TECHNICAL SERVICE BULLETIN

Soft Top Material Wear Above The B-Pillar

23-2229

Ford 2021-2022 Bronco

Figure 1

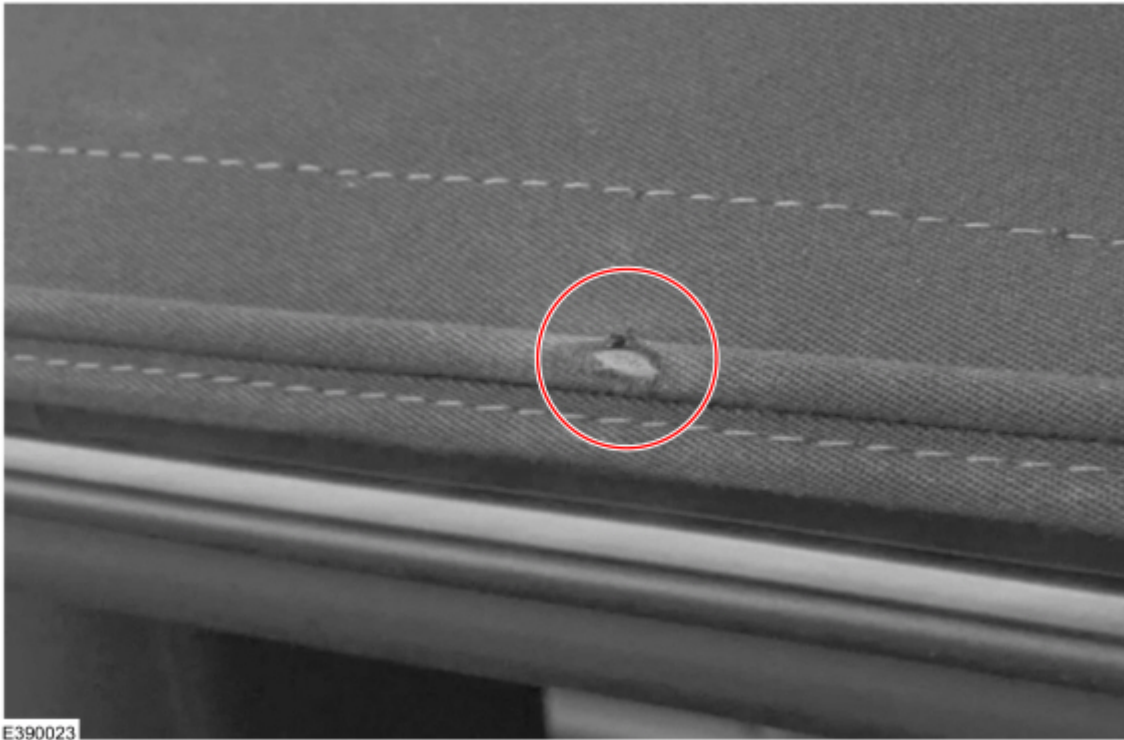
1. Does the soft top exhibit wear above the B-pillar similar to Figure 1?

(1). Yes - proceed to Step 2. Updated deflectors will be installed on both sides of the soft top frame assembly to prevent wear.

Figure 3

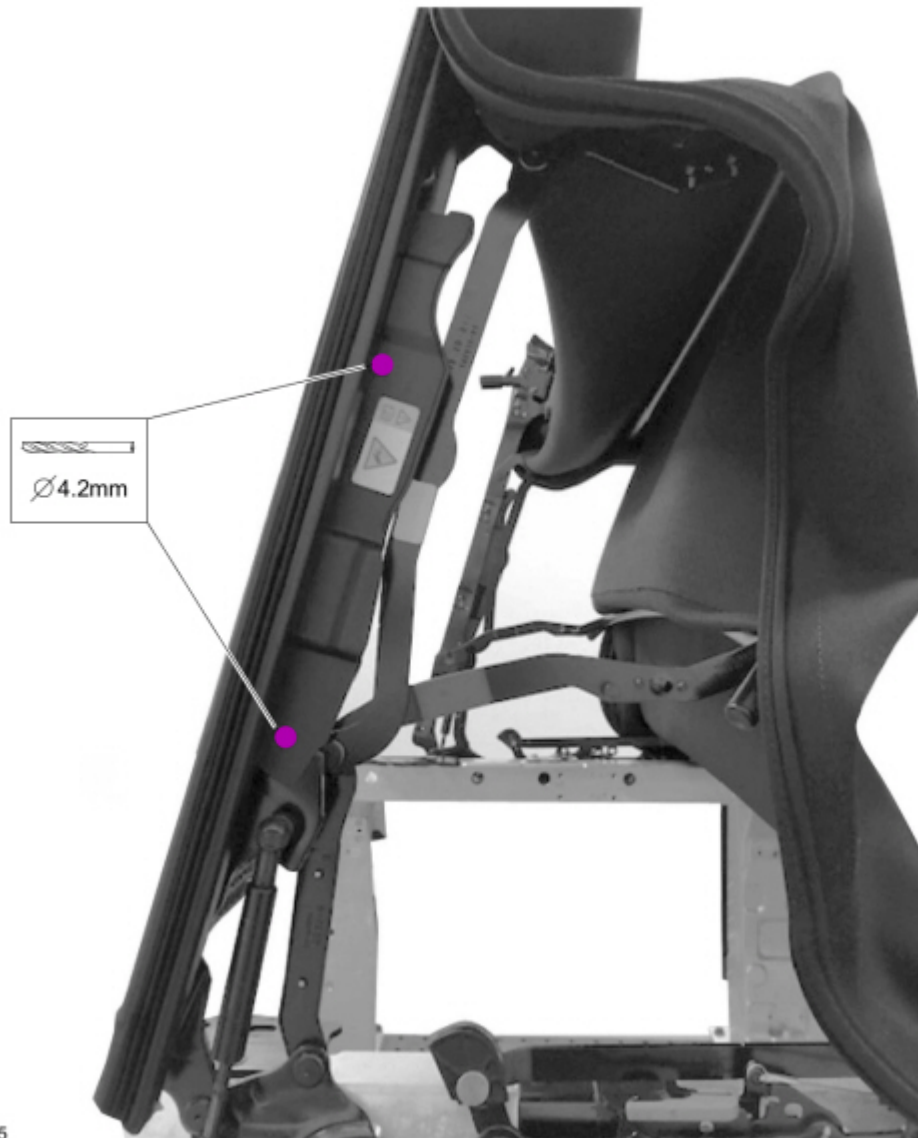
CAUTION: Do not drill through the linkage assembly. Only the head of the rivet should be drilled. Drilling through the linkage enlarges the hole where a new rivet will not fit to secure the linkage.

4. Locate each deflector on the right and left side of the frame assembly and drill out 2 rivets per deflector using a 4.2 mm (11/64 in) drill bit. (Figure 3)

5. Attach an updated deflector on each side of the frame using rivets, securing the new deflector to the frame assembly starting from the front moving to the rear.
6. Remove and replace the soft top cover. Refer to the Workshop Manual (WSM) Section 501-18A Soft Top > Removal and Installation > Soft Top Material.
